Zoning Staff Report

Case Number: ZC-26-041

Zoning Map Amendment

Proposed Use: Data Center / Support Facilities site plan

PD SITE PLAN

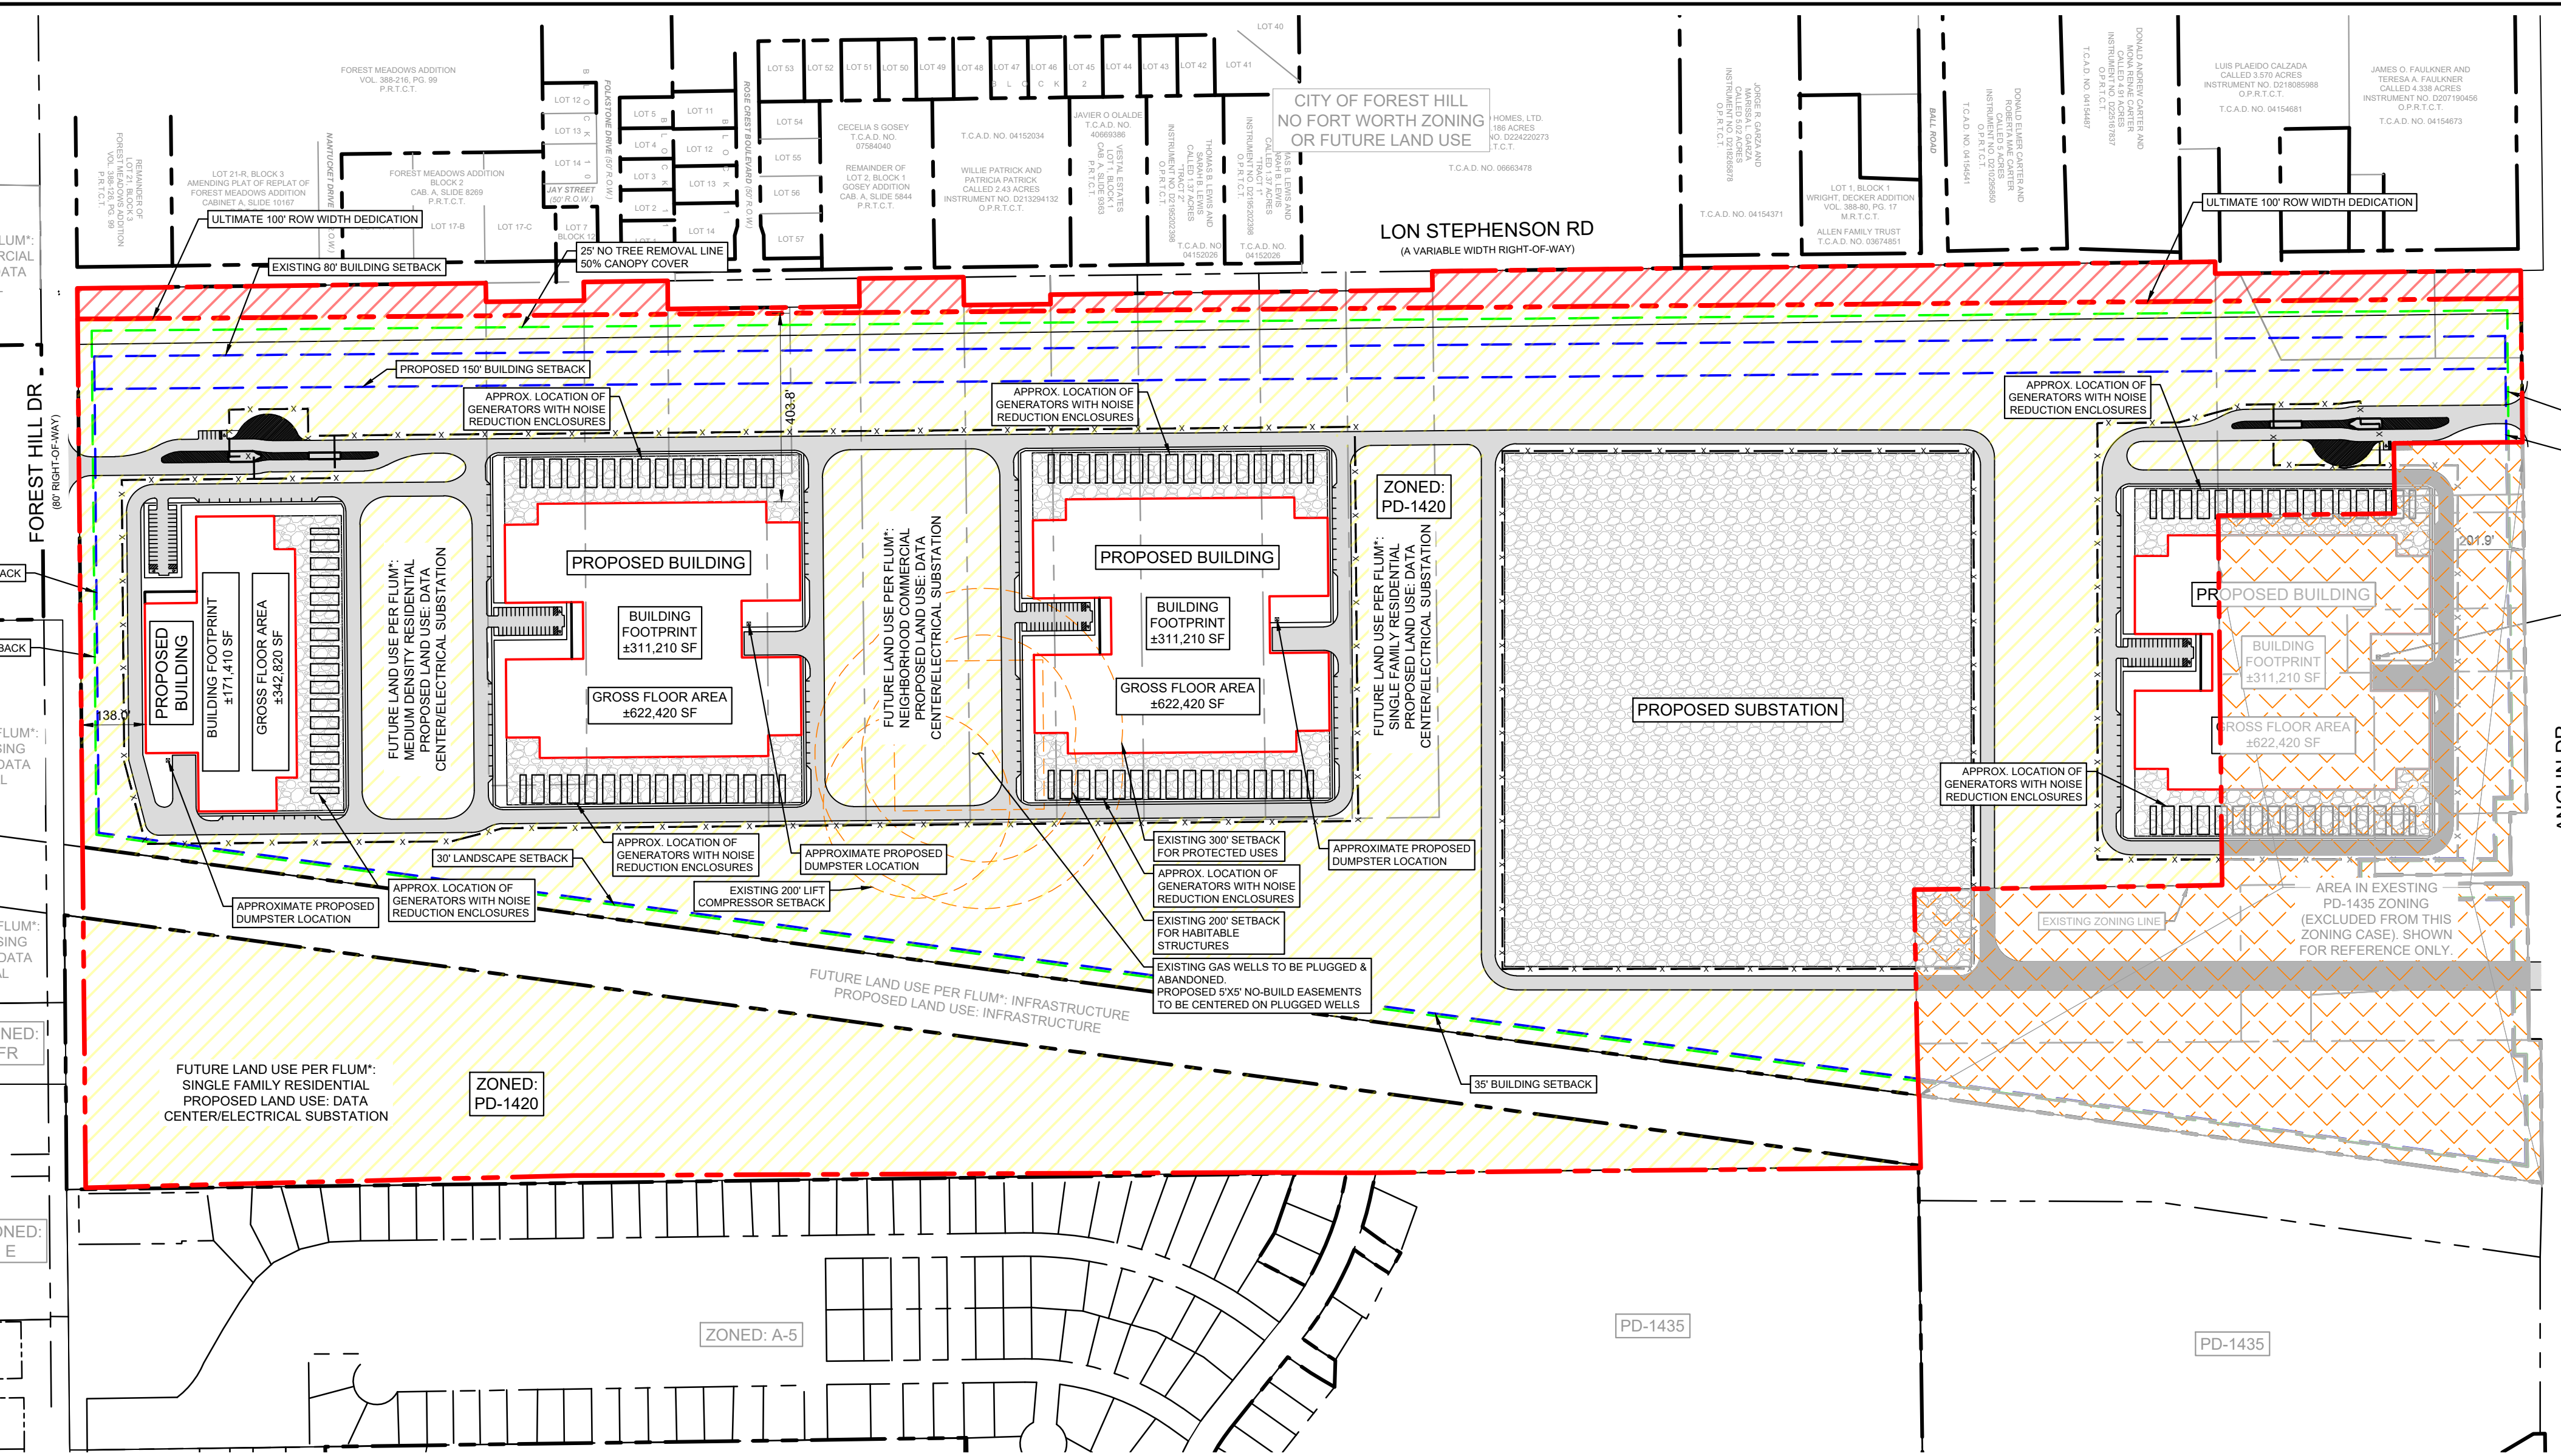
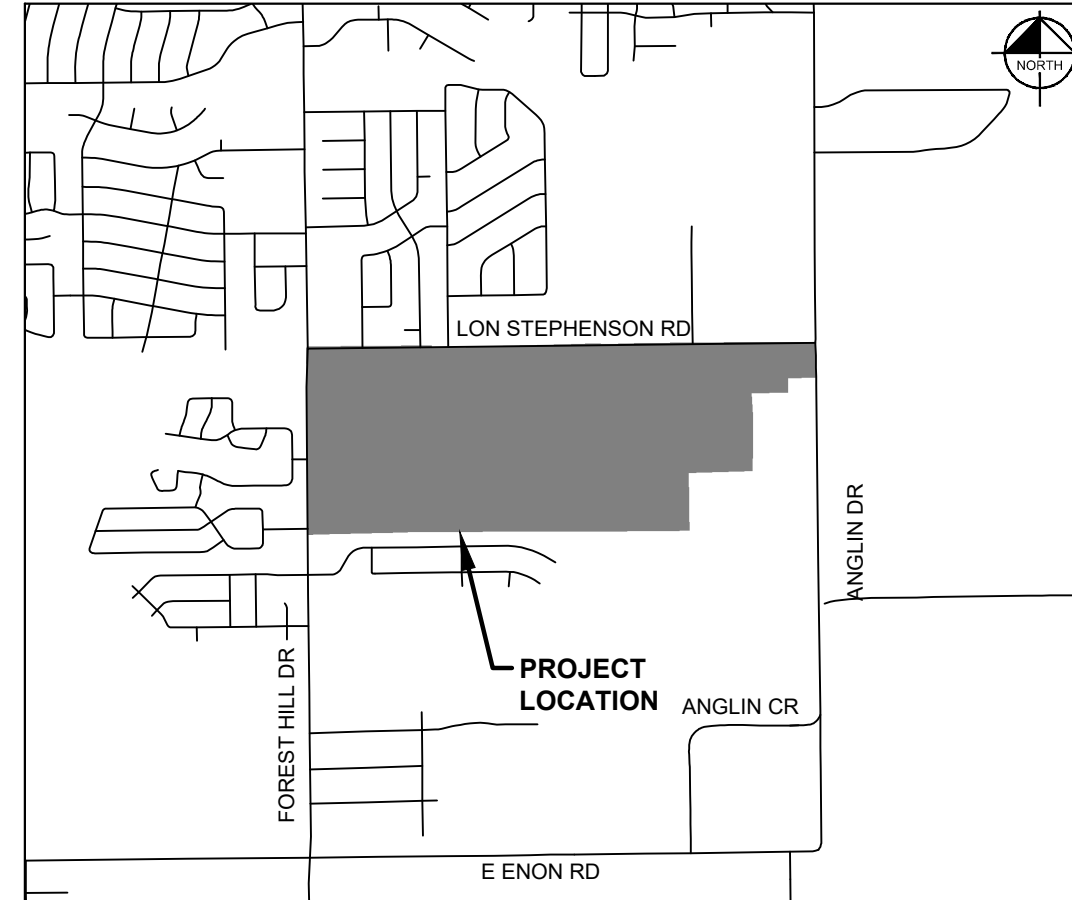
Comments to be addressed on the site plan: Revised 4/17/2026 Zoning comments cleared

- Generator locations and wall need to be identified on the site plan.
- Provide a bold line around the proposed development excluding hatched area.
- Show row widths for Lon Stephenson and Forest Hill, including interior drive isles with surface material.
- Update zoning case number.
- Indicate the type of security fence proposed.
- Show faint the surrounding land uses and lots.
- Is fencing proposed around the substation? If so indicate on site plan height and type.
- Indicate any refuse containers on the site plan.

Hydrants are required for the site to meet the following:

- Maximum of 600 ft. (300 ft. radius) of space between hydrants along a direct horizontal line, and
- Maximum of 500 ft. hose lay distance to all points of building.
- Maximum of 150 ft. for a standpipe system, and/or a sprinkler system.

Marked fire lanes are required. The pavement shown around each building will provide adequate hose lay if marked as such.

Building hose lay is a maximum of 150', measured from a public street or marked fire lane. 300' may be allowed if the building is equipped with a fire sprinkler system and is not considered to be a hazardous materials or high piled storage use. Buildings having a clear ceiling height of 14' are considered high piled storage.

The "half of 2 sides" rule for buildings taller than 55' will only apply if the floor level of the highest occupied floor is 55' above the lowest level of fire department access.

If the project is divided into multiple lots, each lot is required to have one point of access. Otherwise, one access point must be provided to a single large lot.

A non-permitted gas well pad site is located within the project area and has the following setbacks. Commercial uses are considered Habitable.

- 300' Building Setback radii from each gas well bore for Protected Use and Public Building Structures.
- 200' Building Setback radii from each gas well bore for Habitable Structures"
- 200' Building Setback radii from the Lift Compressor for Protected Use, Public Building, or Habitable Structures
- 200' from the tank battery for Protected, Public, and Habitable uses.

TDS does not support this site plan proposal until ROW is clarified and other items are specified in the plan.

1. Ultimate cross-section ROW width for Lon Stephenson is 110 feet, not 100 as shown in the site plan.
2. Ultimate cross-section ROW width for Forest Hill is 110 feet. Unclear if dedication is proposed or necessary.

3. Ultimate cross-section ROW width for Anglin is 80 feet. Unclear if dedication is proposed or necessary.
4. Unclear is the driveway shown on Forest Hill meets Access Management Policy spacing requirements (250 feet from intersections; 200 feet from other driveways)
